# RECORD PLANS

Contractor: DIRT TECH COMPANY, LLC  
 Resident Engineer: GREG WILCOX  
 Construction Began: AUGUST 25, 2017  
 Construction Complete: OCTOBER 23, 2018  
 Record Plans By: TAYLOR WARING & JESSE IVES

## PROPOSED IMPROVEMENT CITY OF SOUTH BURLINGTON COUNTY OF CHITTENDEN I-189 (PRINCIPAL ARTERIAL - INTERSTATE - NHS)

DIRECTOR OF PROJECT DELIVERY	
APPROVED:	DATE 4/19/2017
PROJECT MANAGER :	KEN UPMAL, P. E.
PROJECT NAME :	SOUTH BURLINGTON
PROJECT NUMBER :	IM SCR (21)
SHEET 1 OF 29 SHEETS

MM 1.198  
CULVERT LINING DETAIL

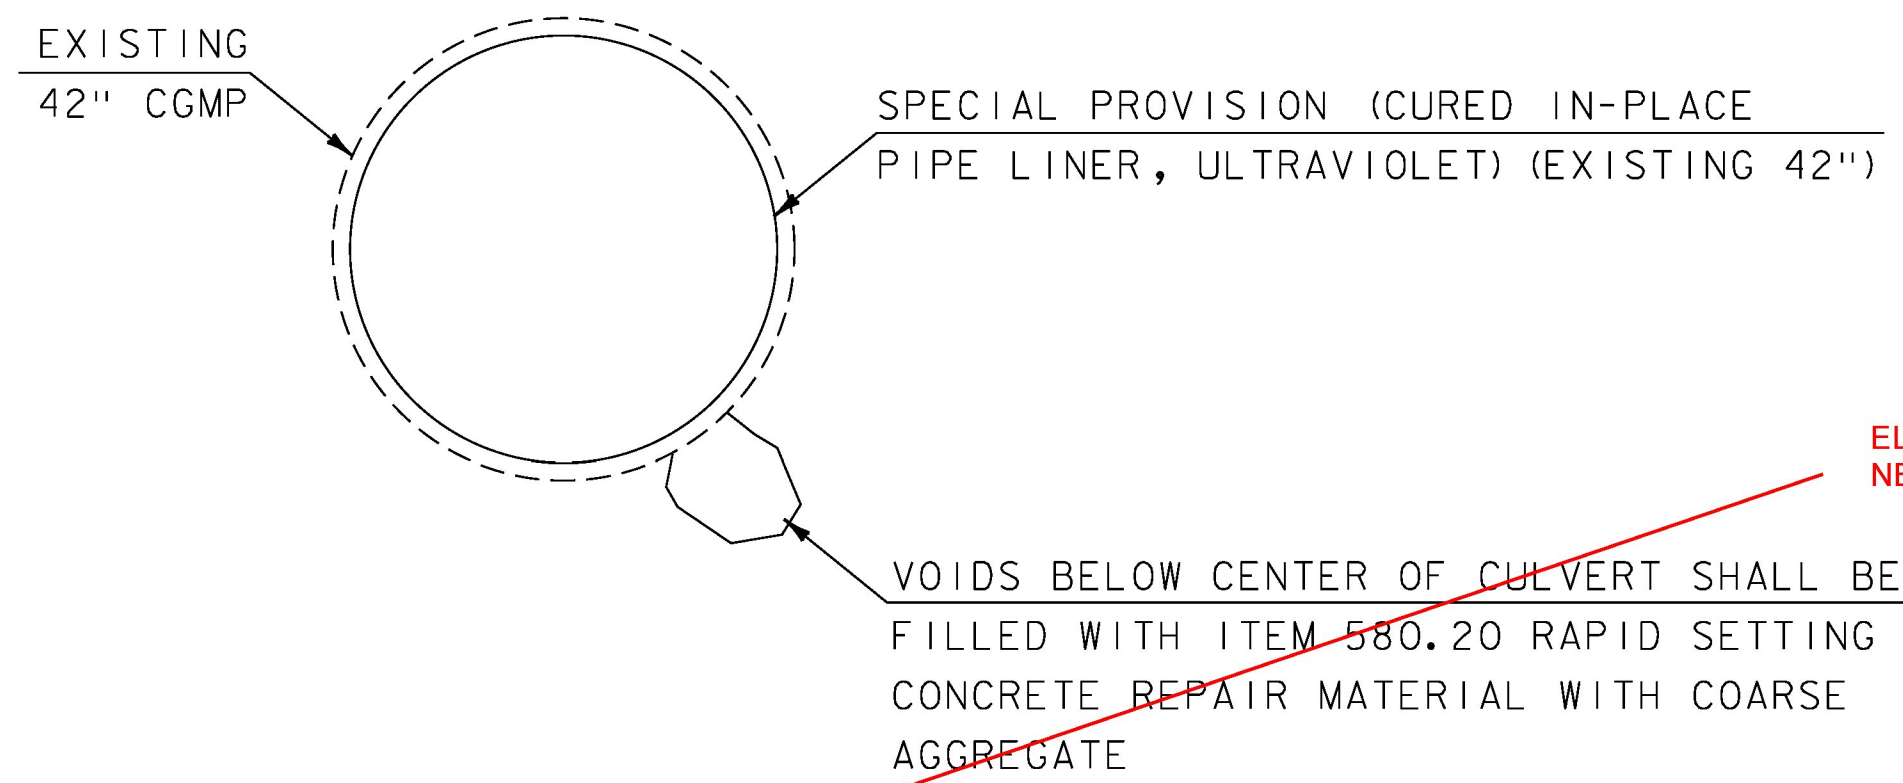
ELIMINATED, NOT NEEDED

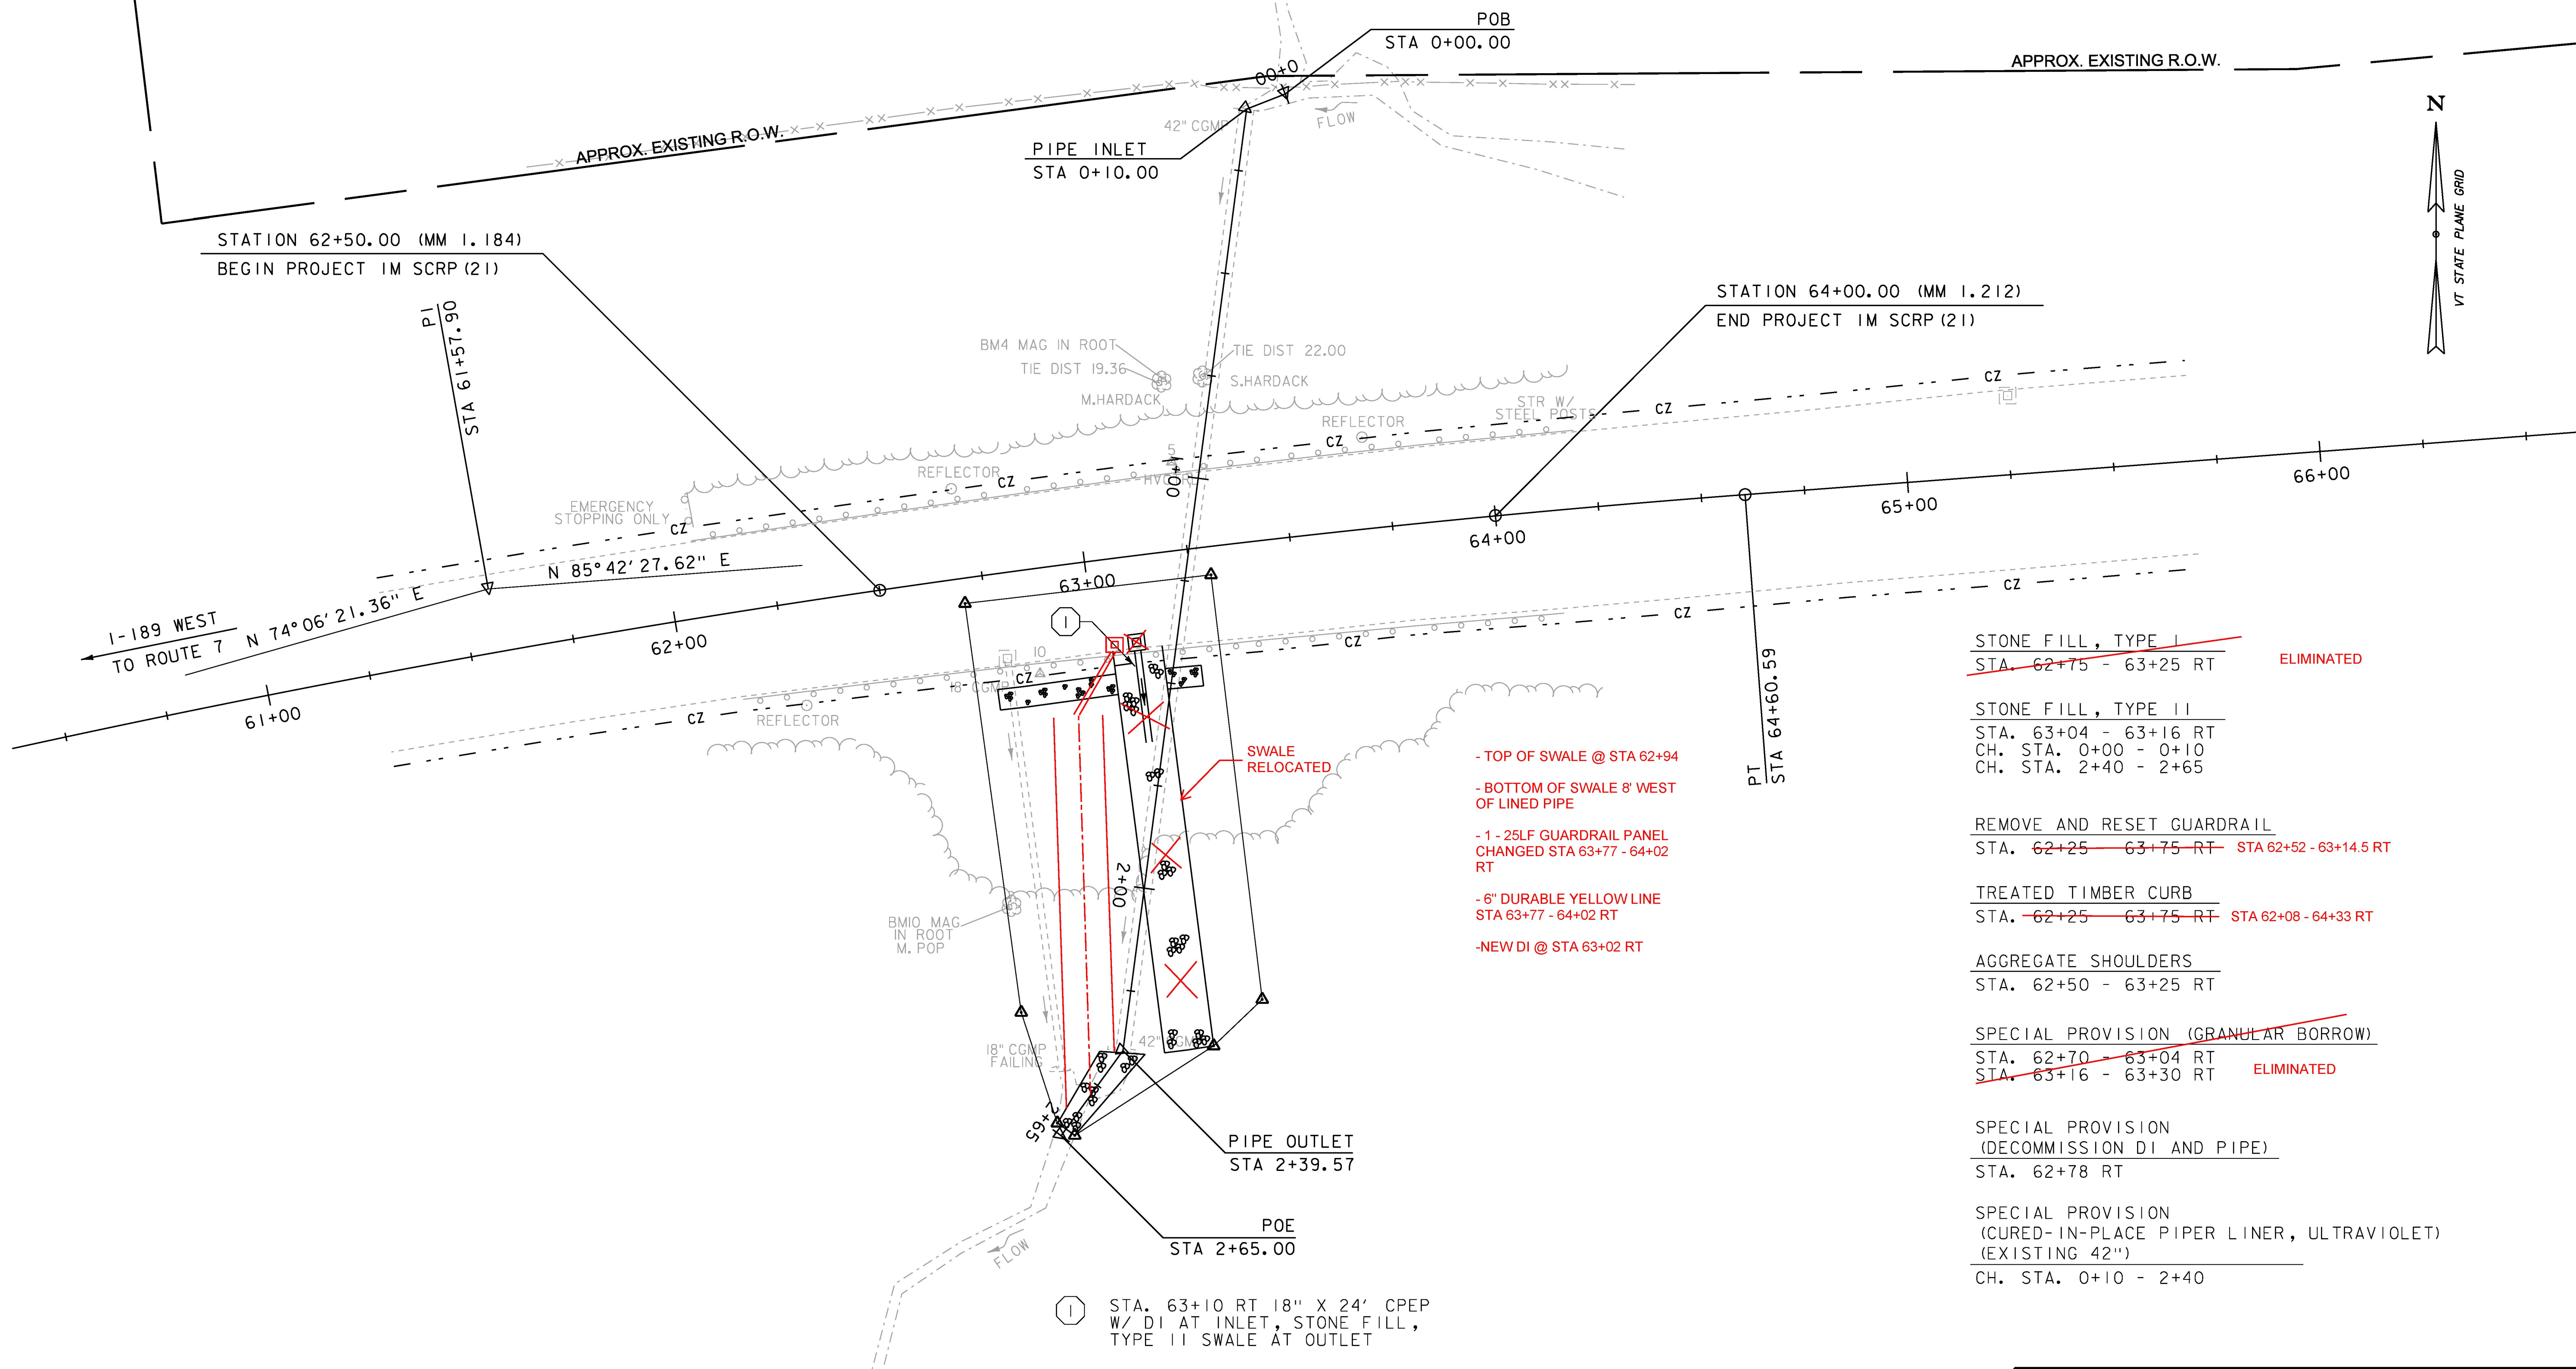
- ~~STONE FILL, TYPE I~~  
STA. ~~62+75 - 63+25 RT~~ ELIMINATED
- STONE FILL, TYPE II  
STA. 63+04 - 63+16 RT  
CH. STA. 0+00 - 0+10  
CH. STA. 2+40 - 2+65
- REMOVE AND RESET GUARDRAIL  
STA. ~~62+25 - 63+75 RT~~ STA 62+52 - 63+14.5 RT
- TREATED TIMBER CURB  
STA. ~~62+25 - 63+75 RT~~ STA 62+08 - 64+33 RT
- AGGREGATE SHOULDERS  
STA. 62+50 - 63+25 RT
- ~~SPECIAL PROVISION (GRANULAR BORROW)~~  
STA. ~~62+70 - 63+04 RT~~  
STA. ~~63+16 - 63+30 RT~~ ELIMINATED
- SPECIAL PROVISION  
(DECOMMISSION DI AND PIPE)  
STA. 62+78 RT
- SPECIAL PROVISION  
(CURED-IN-PLACE PIPER LINER, ULTRAVIOLET)  
(EXISTING 42")  
CH. STA. 0+10 - 2+40

- TOP OF SWALE @ STA 62+94
- BOTTOM OF SWALE 8' WEST OF LINED PIPE
- 1 - 25LF GUARDRAIL PANEL CHANGED STA 63+77 - 64+02 RT
- 6" DURABLE YELLOW LINE STA 63+77 - 64+02 RT
- NEW DI @ STA 63+02 RT
